Subject: Review meeting 7/16/19 Lavitt property PV Planning from Phil Hagenah

Re: Preliminary Plat for Lavitt Manor II—Two Lot Subdivision: 7525 N. Ironwood Drive

5. PUBLIC HEARINGS 19-302 CONSIDERATION OF PRELIMINARY PLAT

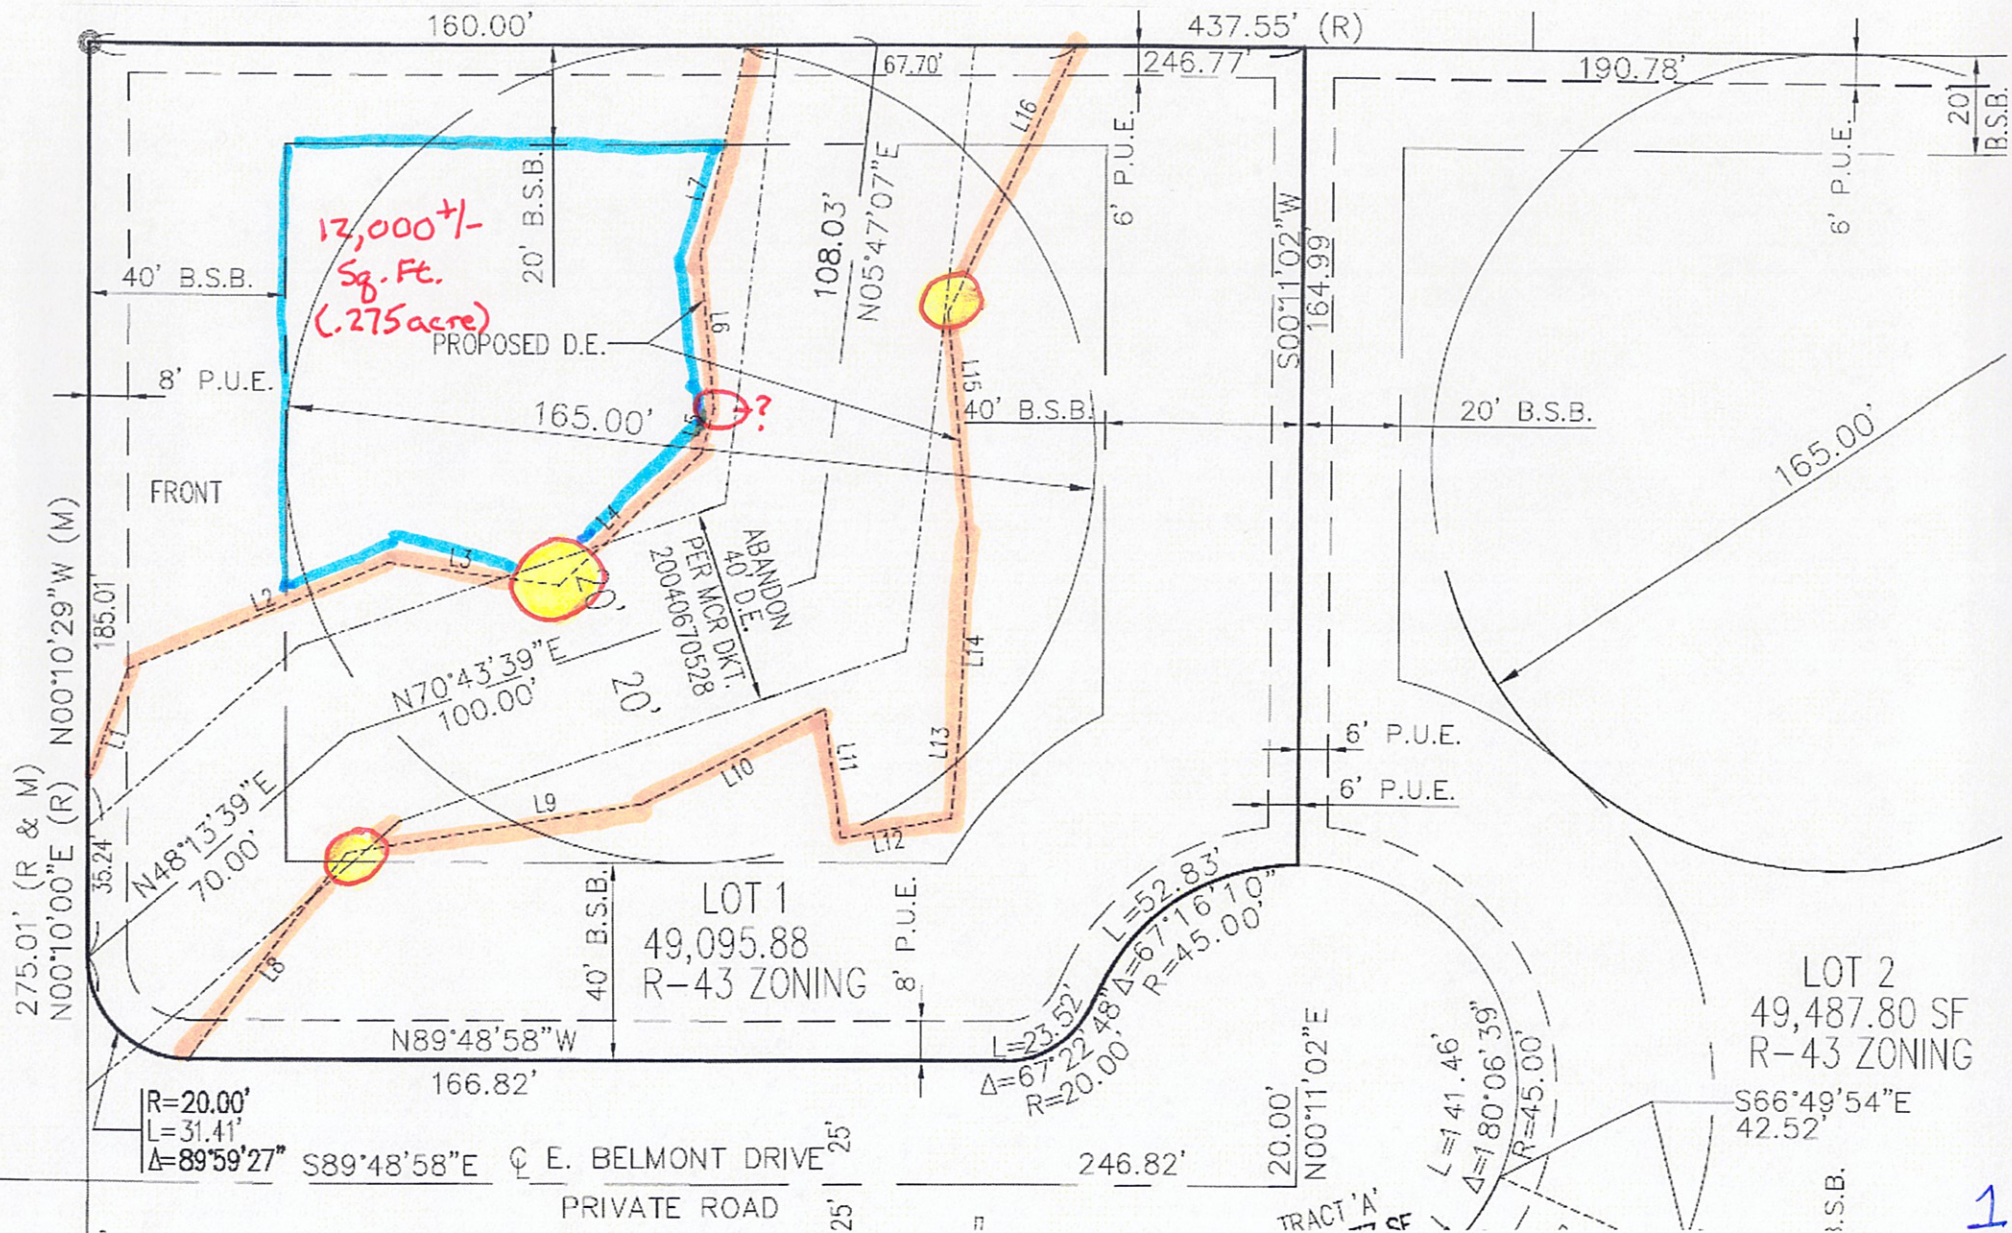
Town Code 3.6(A)(3): Natural Wash Preservation: "Town rights-of-way and easements along Natural Wash corridors shall be maintained to preserve the natural environment and landscape features. Natural Wash Corridors shall include a landscape buffer of at least 5 feet on each side, perpendicular from the **top of the bank** and designed to protect the wash's functional and ecological integrity."

- Town of Paradise Valley is obtaining easement on Lot 1;
- Mandatory language ("shall") to have a 5 foot landscape buffer on each side of wash;
- Current easement points approaches or encroaches Natural Wash at 3 points thus the landscape buffer is not appropriate;
- Plan should not be approved as it violates the Town Code.

DRAWING NO:
C3 of 4

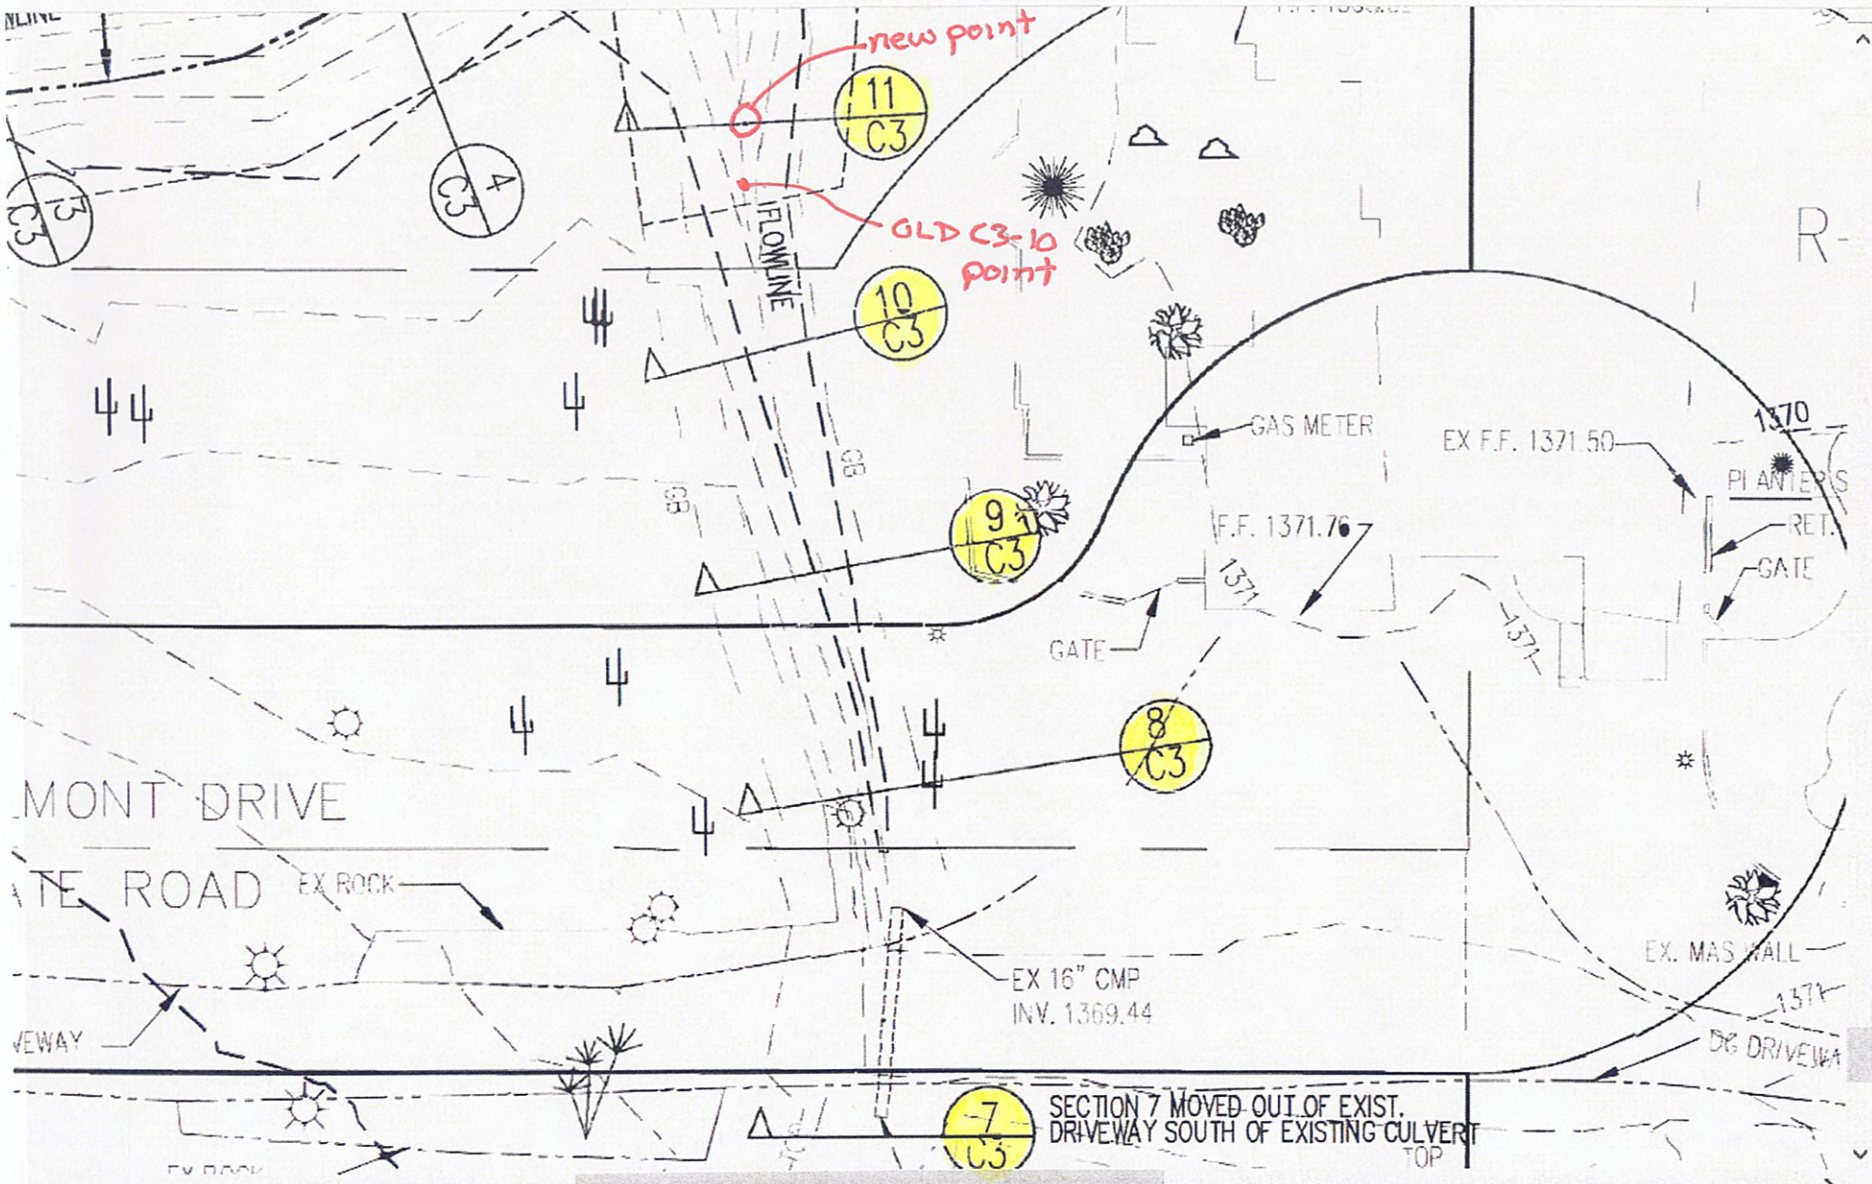
With this understanding, the revised plat points provided by the Applicant on page C3 of 4 of the Preliminary Plat for the Southern Drainage Channel, demonstrate the southern wash meets the definition of a "watercourse" and "Natural Wash" (Exhibits 2-8). The Applicant only took measurements from the shallow side of the wash to reach his conclusion the wash does not require an easement be provided to the Town of Paradise Valley. But as we all know, a wash has two banks—not one. The Code and *Storm Drainage Design Manual* requires measurements from the "top of the bank, which as discussed above, means both banks. When the measurements are reviewed for both sides of the southern wash, it meets the definition of a watercourse and Natural Wash. Applicants must dedicate this wash to the Town.

Plat Points	Elevation Pt. 1	Elevation Pt. 2	Depth of Wash	Width of Wash
C3-7	1373.2	1369.8	3.4 feet	18.5 feet
C3-8	1373.0	1369.7	3.3 feet	8.5 feet
C3-9	1372.0	1369.6	2.4 feet	10.6 feet
C3-10	1371.0	1369.3	1.7 feet	12.0 feet
C3-11	1370.1	1368.2	1.9 feet	14.0 feet

SECTION

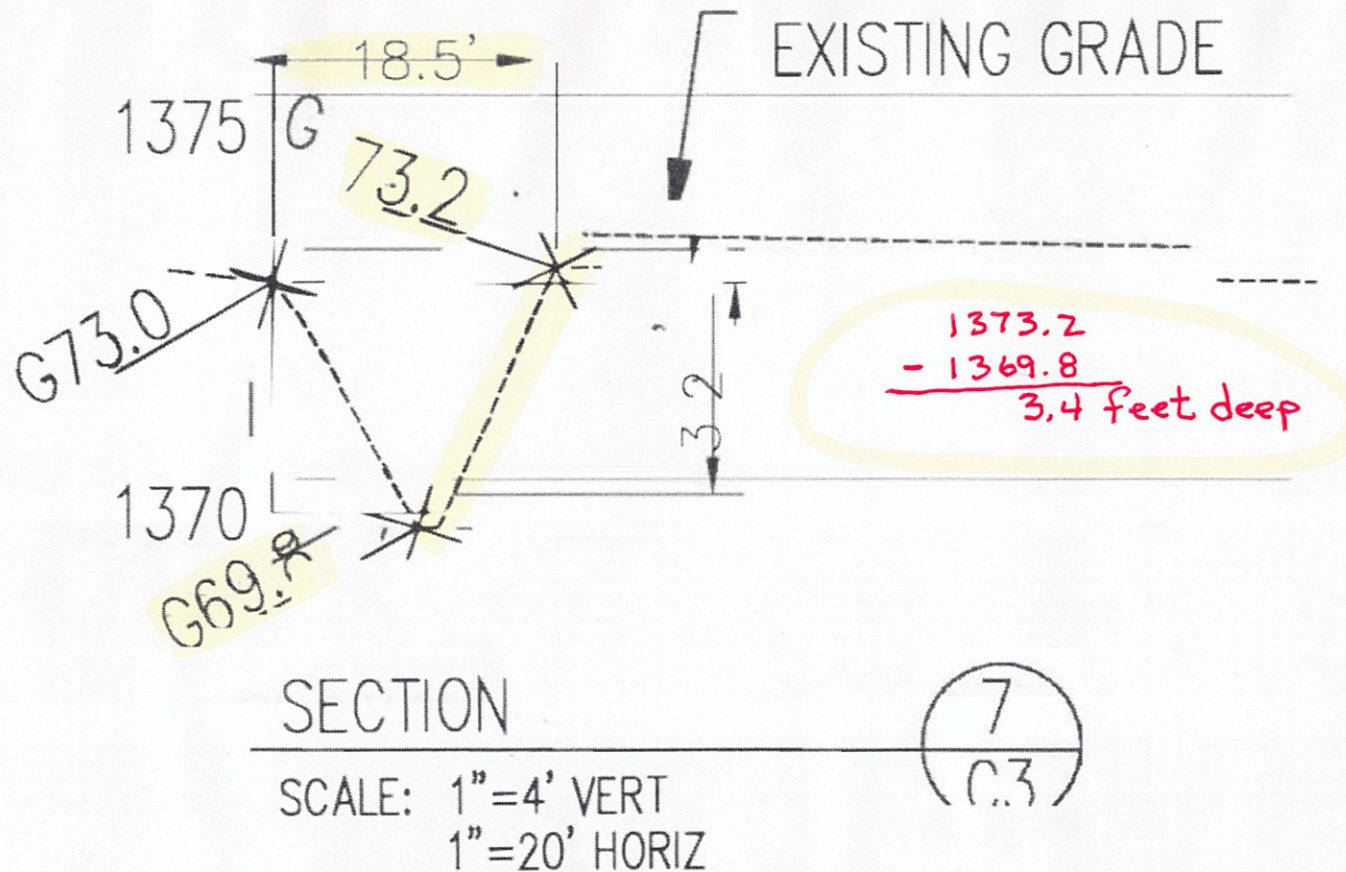
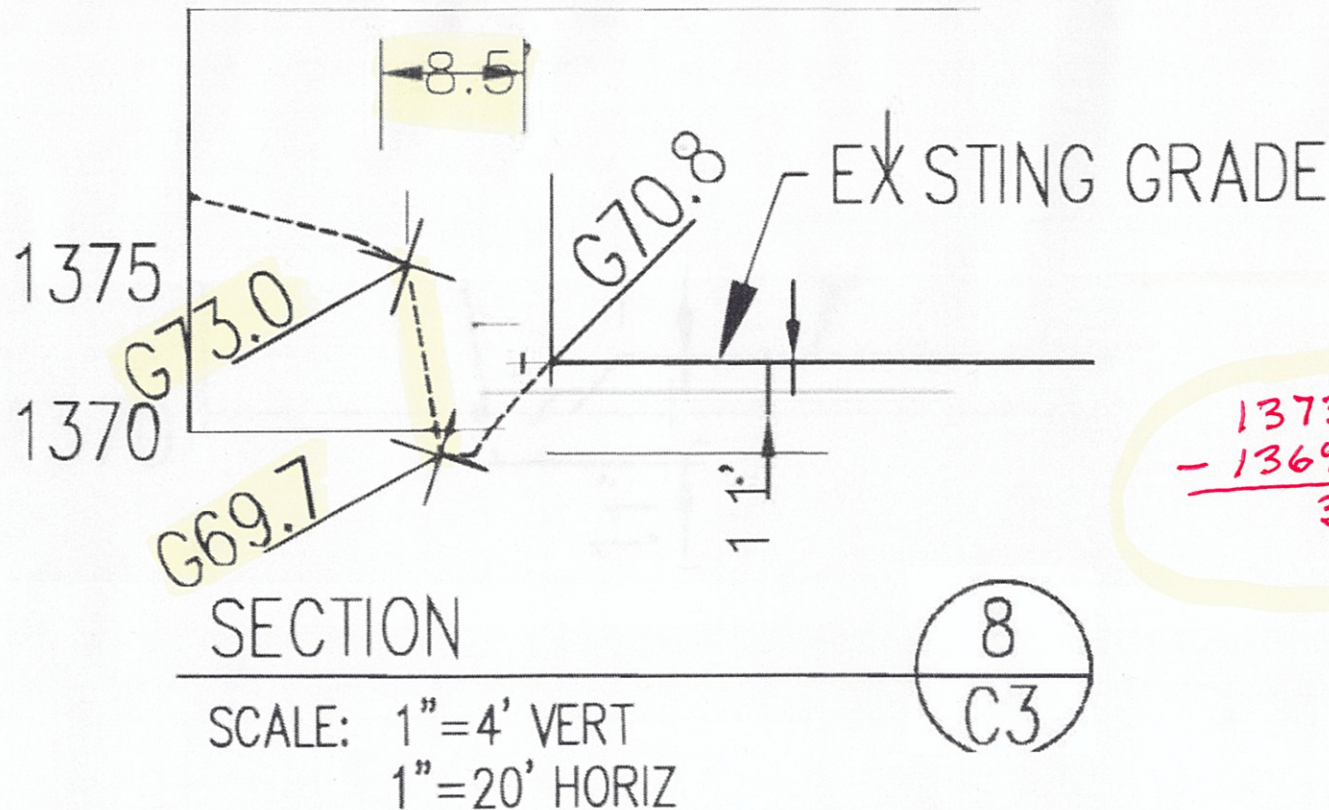
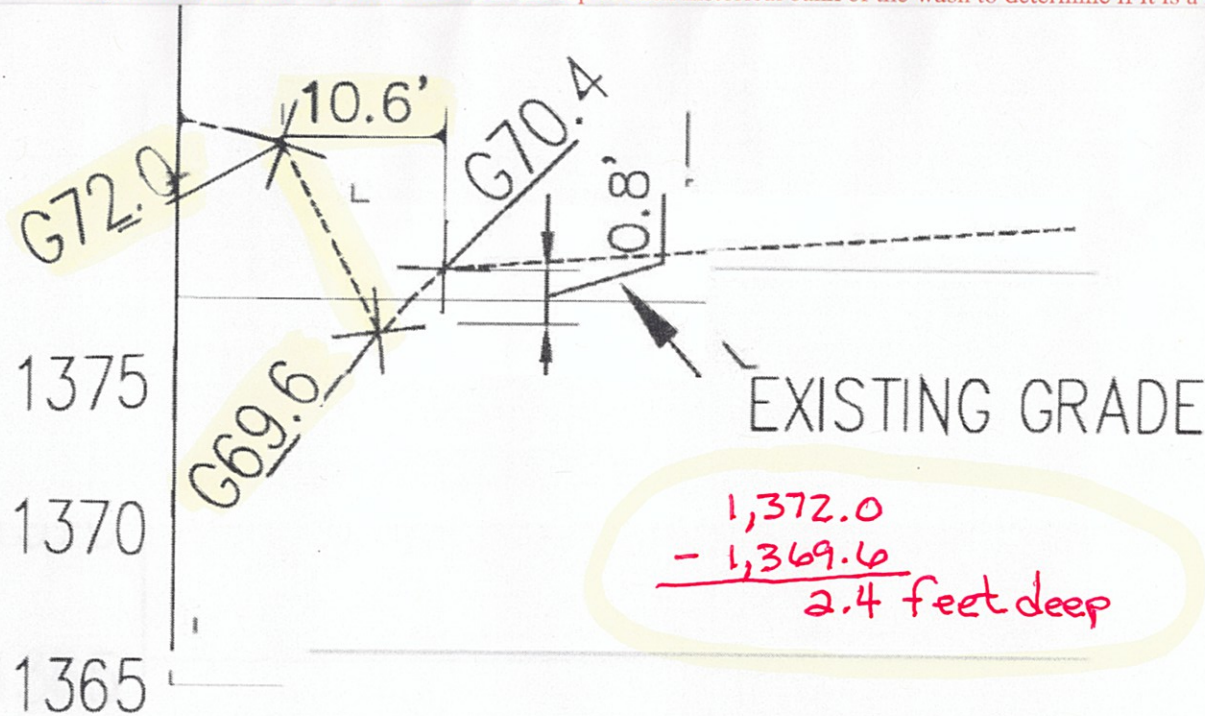
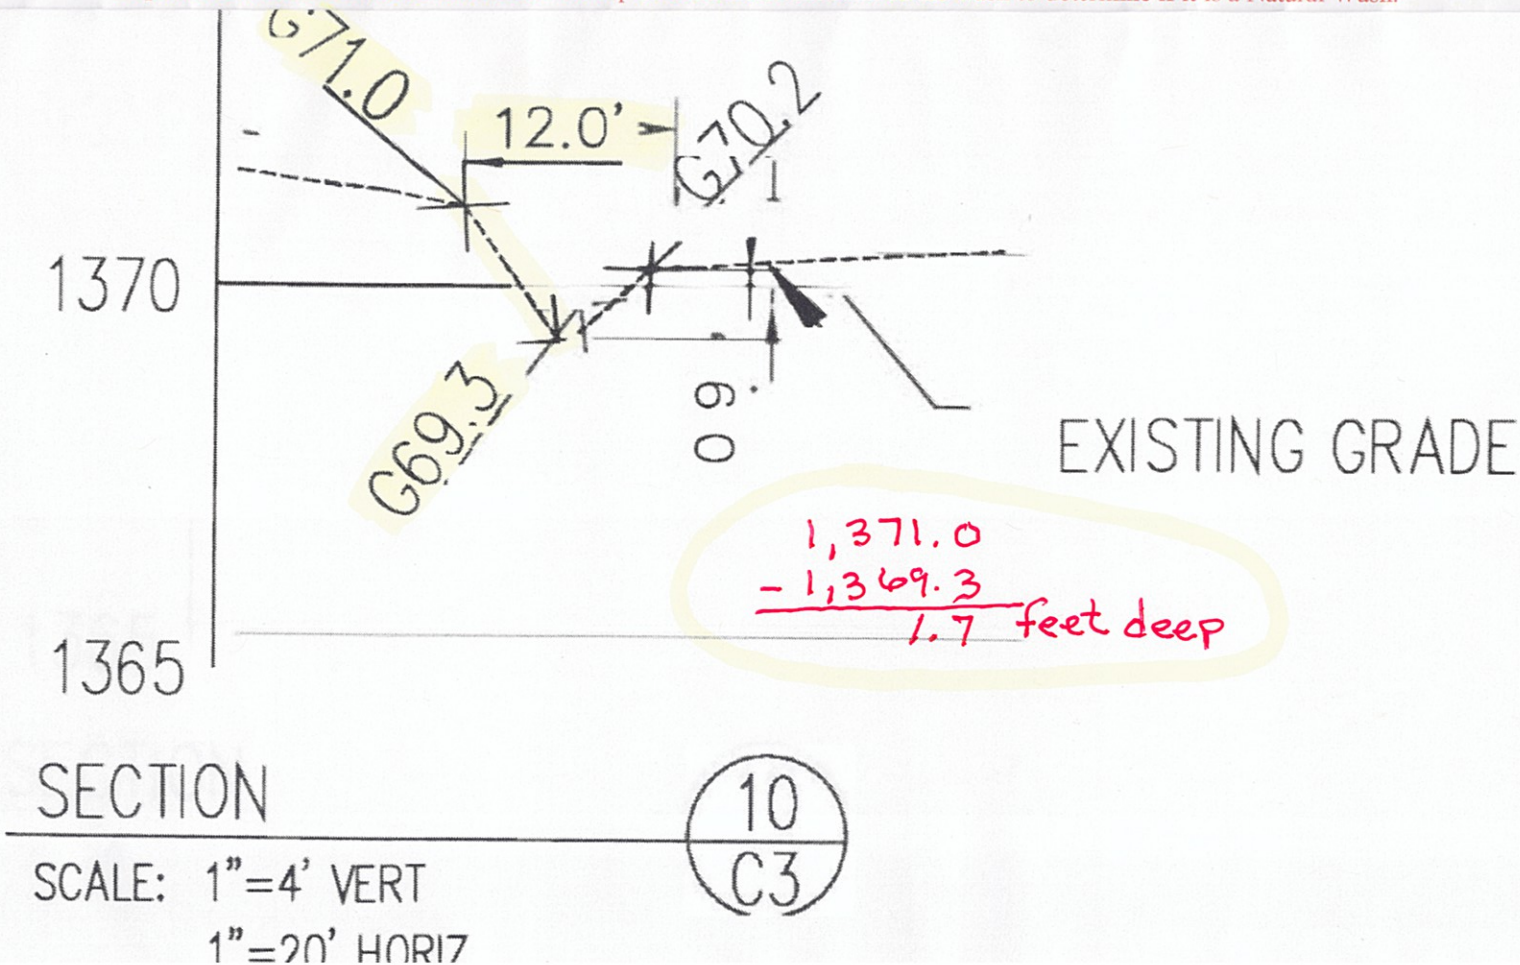
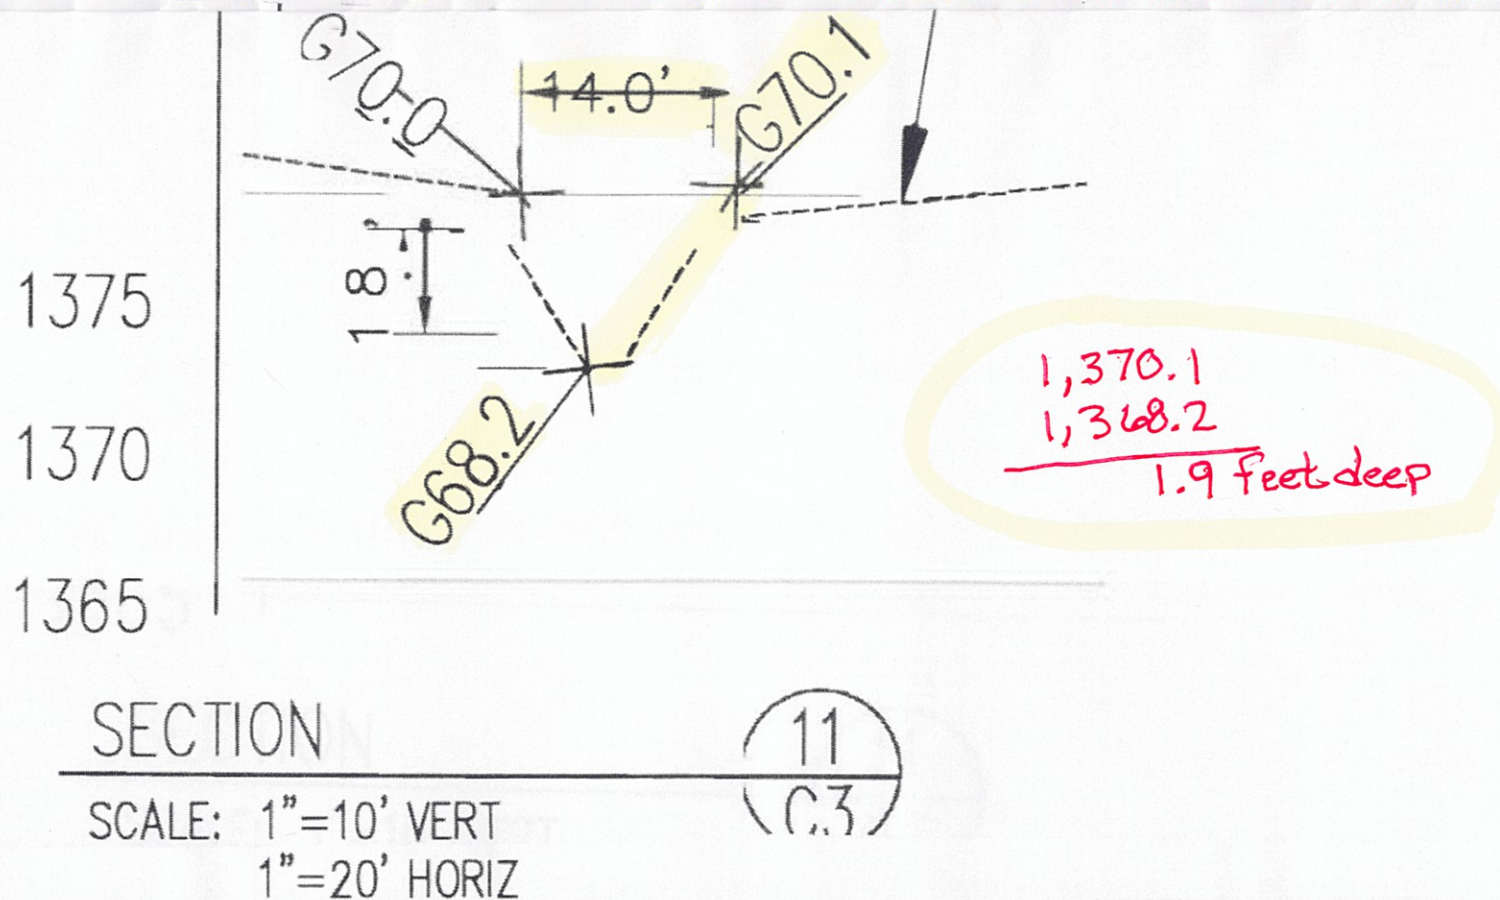
- Must consider both "historical banks" to determine depth;
- Nowhere does it say watercourse depth is taken from one bank, lowest bank, or existing grade of one bank.

- Width must be determined by taking a measurement at the "top of the bank";
 - Can only mean at the top of each bank, or one could not obtain a width measurement from one bank.
- Accordingly, to ensure the same "top of the bank" meaning throughout the provisions, "top of the bank" must mean top of each bank;
 - Depth measurements must be taken from the top of each historical bank of the wash.

- Width must be determined by taking a measurement "to the top of the bank";
 - Can only mean to the top of each bank, or one could not obtain a width measurement from one bank.
- Accordingly, to ensure the same "top of the bank" meaning throughout the provisions, "top of the bank" must mean top of each bank;
 - Depth measurements must be taken from the top of each historical bank of the wash to determine if it is a Natural Wash.

$$\begin{array}{r} 1373.0 \\ - 1369.7 \\ \hline 3.3 \text{ feet deep} \end{array}$$
